**STAFF REPORT:** 02/11/2026 MEETING  
**APPLICATION NUMBERS:** HDC2025-00741  
**VIOLATION NUMBER:** 1077  
**ADDRESS:** 2008 LONGFELLOW  
**HISTORIC DISTRICT:** BOSTON-EDISON  
**APPLICANT/PROPERTY OWNER:** NEVAR JAHWARY, STONEBRIDGE DEVELOPMENT  
**DATE OF PROVISIONALLY COMPLETE APPLICATION:** 01/20/2026  
**DATE OF STAFF SITE VISIT:** 01/28/2026

**SCOPE:** DEMOLISH AND REBUILD FRONT AND REAR PORCHES; DEMOLISH AND REBUILD UPPER WALLS AND WINDOW OPENINGS AT SIDE PORCH; REMOVE WOOD WINDOWS AND INSTALL NEW WOOD WINDOWS; INSTALL FOUR (4) ENTRY DOORS AT REAR; INSTALL ASPHALT SHINGLE ROOF AND REBUILD EAVES (WORK STARTED WITHOUT APPROVAL)

## Front wall/façade

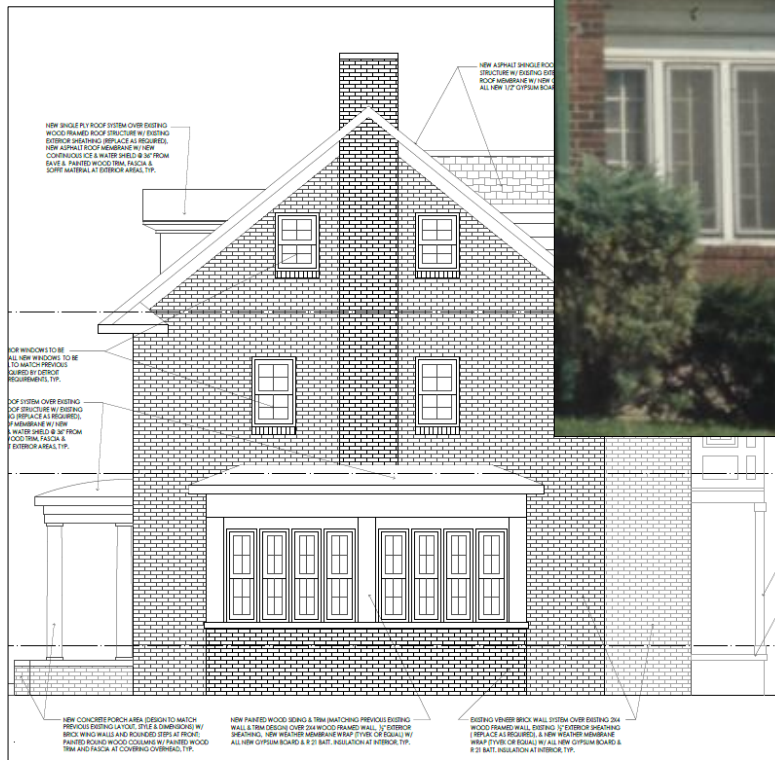
- Previous windows at Palladian dormer were casements with a nine-light pattern (now proposed as six-lights) and the central arched window had an undivided light bottom sash (staff believes that to be the original condition based on documented original casement windows on the side walls, which are discussed on following pages) and not a divided lower sash as proposed.

- Dentil trim at the soffit/eave was removed and its placement is noticeable on existing condition photos. It has not been included on the elevation; nor did the applicant reply to staff's inquiry; therefore, it is staff's assumption it will not be replicated.

- The triple window openings at the first floor were 4-over-1 with a central 8-over-1 pattern.
- Double window openings at second floor (mullered and single openings) were 6-over-1 double-hung windows.

- The drawings appear to show a close replication of the half-round raised and covered porch, except for the columns. The original columns were tapered, with a smooth finish and Tuscan capitals and bases. Staff doesn't know if the columns remain on site, nor their dimensions. The drawings do not replicate the original columns. Also, there is a square shaped concrete block foundation outline at grade, which doesn't match the previous curved porch, stairs and splayed side walls.

- Chimney is not depicted on elevation drawing.

*Applicant photo and elevation drawing.*

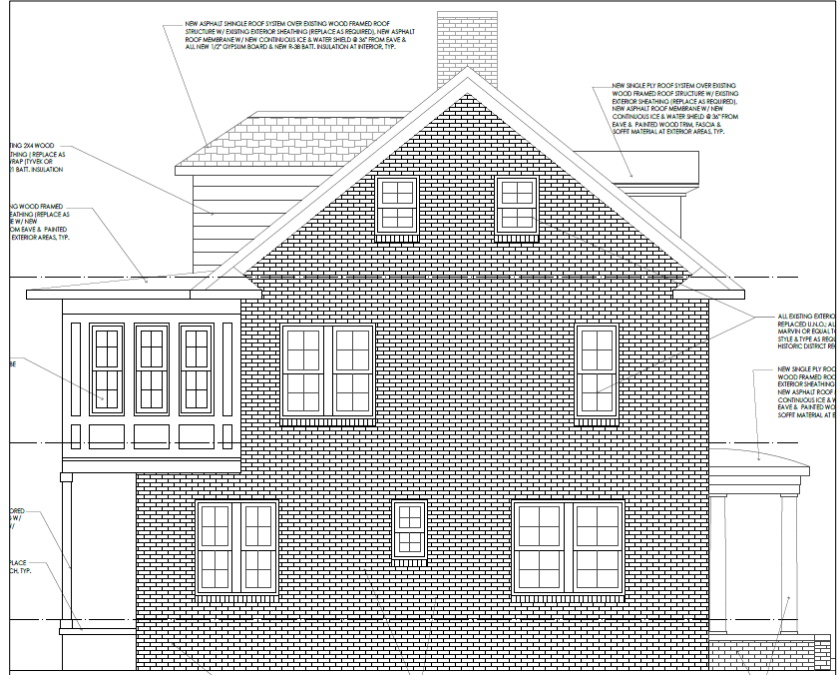
- The massing and roof pitch for the central dormer is drawn differently than existing conditions.
- Detailing for the second floor enclosed porch walls appears to be similar to photo documentation of the area prior to its demolition. However, staff doesn't believe the proposed 4-over-4 double-hung is compatible for this property and location based on evidence of windows having a 4, 6, or 8-over-1 pattern.

- The proposed design of the lower porch and supporting posts do not match the footprint and massing of the original design, and the loss of symmetry and balance, integral to the overall classical revival design, is not a compatible design.

- Operation and dimensions of some window openings on the rear wall drawing (i.e., the central bay openings at the first and second floor) differ from existing conditions. The windows that remain in place at the first and second floor are replacement units similar to those at the front wall and west wall and were not approved by the HDC. Therefore, new double-hung windows at this location must match the original windows in design, operation and material (which likely would have matched the documented three-part window on the front wall that had two narrow 4-over-1 windows and a central 8-over-1 window).

**West-Side wall**

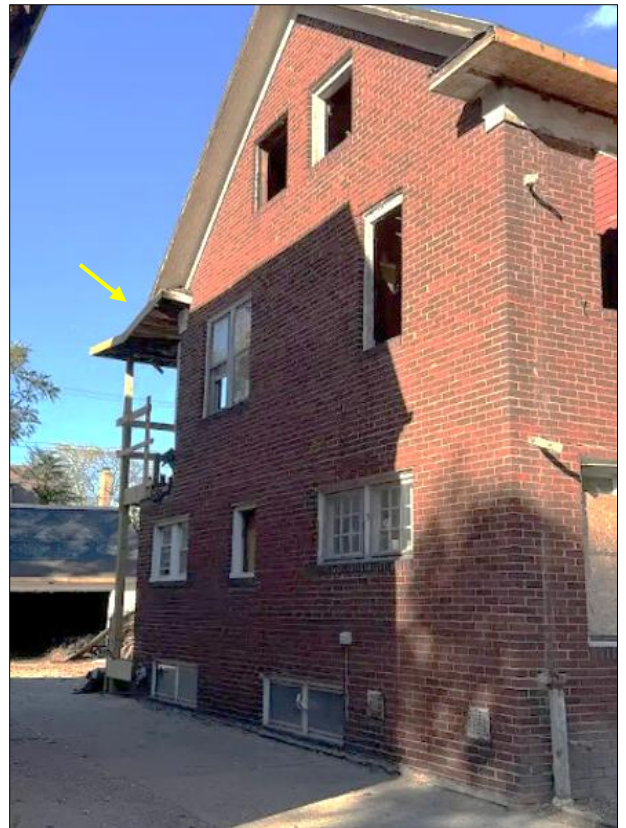
- Similar to the east side elevation drawing, this drawing shows differently sized windows at the third floor, change in operation and design for the opening.

- At the second floor, the single window opening appears to be narrower on the drawing than existing conditions and 4-over-4 double-hung windows proposed for all three windows; counter to the historic (and still existing in a few window openings) pattern.

- At the first floor, the window openings at center and near the rear had replacement windows in them recently (and the mullied opening may still have them), which staff confirmed were not approved by the HDC. Original windows are intact at the forward positioned windows, with 9 or 12-light casement (or fixed) windows.

- From the angled view of the applicant’s photo, it looks as though a butterfly roof has been constructed at the second floor rear porch, rather than a generally flat/low pitched roof.

- The elevation drawing shows the mullied openings at the first floor will be enlarged and window operation will change from casement to double-hung.
- Basement window openings are not drawn on the elevation, so staff assumes the openings will be removed. Details are needed on how this will be done (such as retain inset openings with new brick and retention of sills?).
